Re: Florida Power & Light Company
Proposed Turkey Point Units 6 and 7
Docket Nos. 52-040 and 52-041
Response and Revised Response to NRC Request for Additional
Information Letter No. 082 (eRAI 7811) SRP Section
02.05.04 – Stability of Subsurface Materials and Foundations

NRC RAI Letter No. PTN-RAI-LTR-082

NRC RAI Number: 02.05.04-26 (eRAI 7811)

Figure 1 Primary Grout Borehole Layout

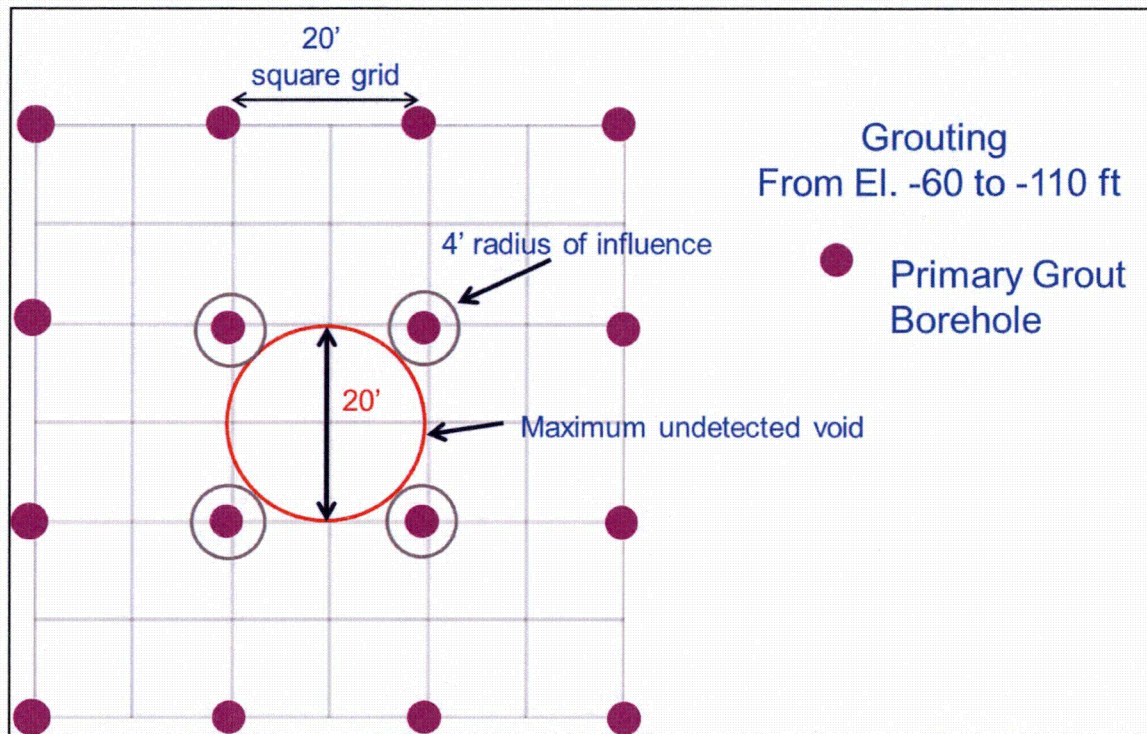
1. Clarification and demonstration that only the voids greater than the 25-foot spherical diameter and/or 12-foot cylindrical diameter at an elevation of about -60 feet are critical to the stability of subsurface materials and the integrity of structures, systems, and components (SSCs).

3. Additional details on the planned microgravity gravity survey specifically:
 - a. Address the size of the areas to be investigated
 - b. Will measurements be conducted along profiles or the entire excavated surfaces surveyed

Instead of developing the critical void size via microgravity methods, which can only detect large voids at depth, the subsurface grouting program, which was planned only for dewatering purposes, will be considered in the determination of constrained void sizes. Part 4 of this response provides an Inspection, Tests, Analyses, and Acceptance Criteria (ITAAC) to ensure that the zone between El. -35 feet and El. -60 feet within the diaphragm walls will be grouted according to the closure criteria that will be developed as part of the grout test program. This grouting will ensure that any potential voids in this zone are filled. In addition, for the zone between El. -60 feet and -110 feet within the diaphragm walls, grouting will be performed in every primary grout borehole. Primary grout holes will be spaced less than or equal to 20 feet on center. This

configuration, as shown in Figure 1, is expected to constrain the maximum undetected void size to approximately 20 feet.

radius of influence of 4 feet, corresponds to a sphere shaped void with a maximum 20 feet equivalent diameter (as shown in Figure 1).

Figure 1 Shear Wave Velocity Profile

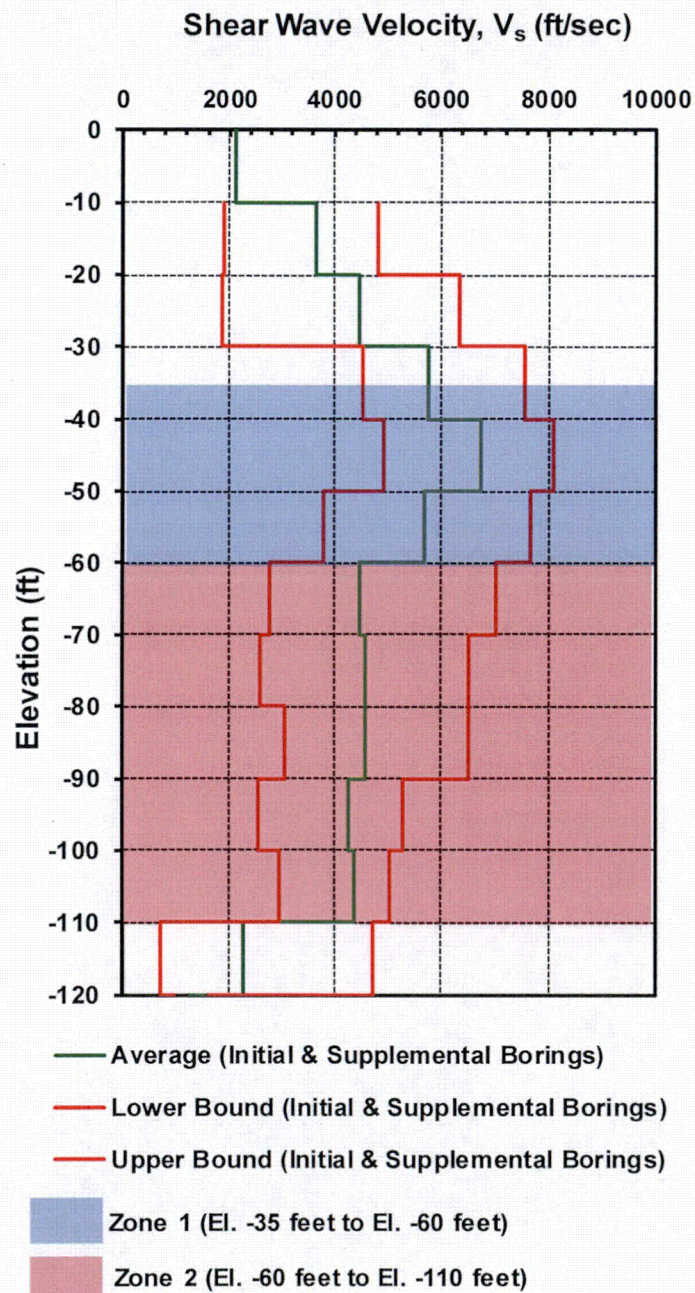
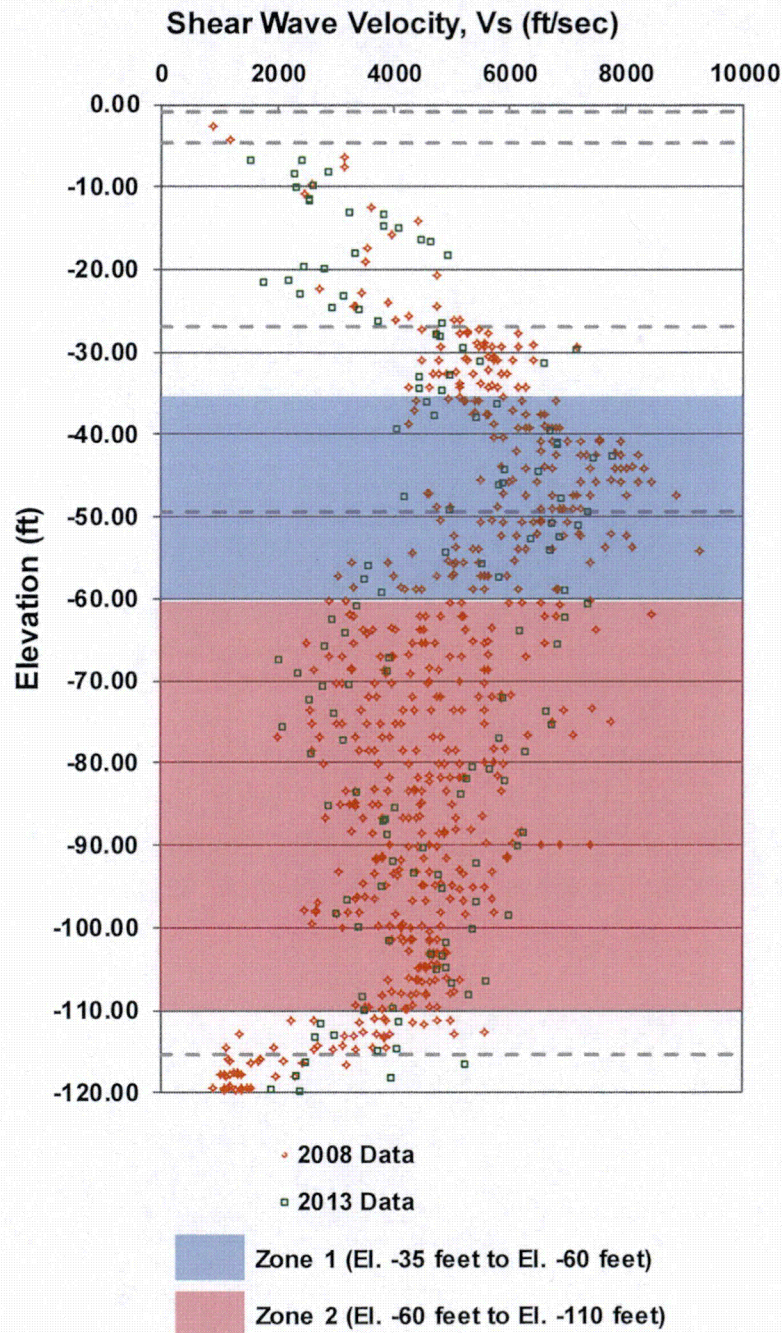
FSAR Subsection 2.5.4.5.4 states that grouting will be conducted beneath the nuclear island between the elevations of approximately -35ft and -60 ft to form a grout plug for construction related groundwater control. In accordance with 10 CFR 100.23 and RG 1.208, please describe what inspection and test programs will be conducted for ensuring the shear wave velocity post grouting is consistent with the shear wave velocity used in the site response analyses you performed in your previous calculation of the GMRS in FSAR Subsection 2.5.2.6.

The grouted zone (Zone 1) between El. -35 feet and El. -60 feet encompasses approximately 14 feet of the Key Largo Limestone Formation (average top El. -27 feet) and approximately 11 feet of the Fort Thompson Formation (average top El. -49.4 feet). This zone shows the shear wave velocity profiles ranging from approximately 4000 ft/s to 8000 ft/s, as seen on Figures 1 and 2.

As described in the Response to RAI 02.05.04-26, primary grout boreholes will be drilled and pressure grouted between El. -60 feet and -110 feet to constrain the size of postulated voids in the Fort Thompson Formation below Zone 1. The extended zone (Zone 2) between El. -60 feet and -110 feet shows the shear wave velocity profiles ranging from approximately 2500 ft/s to 7000 ft/s, as seen on Figures 1 and 2.

If there is a change in shear wave velocity due to grouting, it is expected that the post-grouting shear wave velocity would be higher than the pre-grouting shear wave velocity. Further, any increase in shear wave velocity of the Key Largo and Fort Thompson formations is not expected to cause any increase in SSI analysis results, if the input motion remains the same.
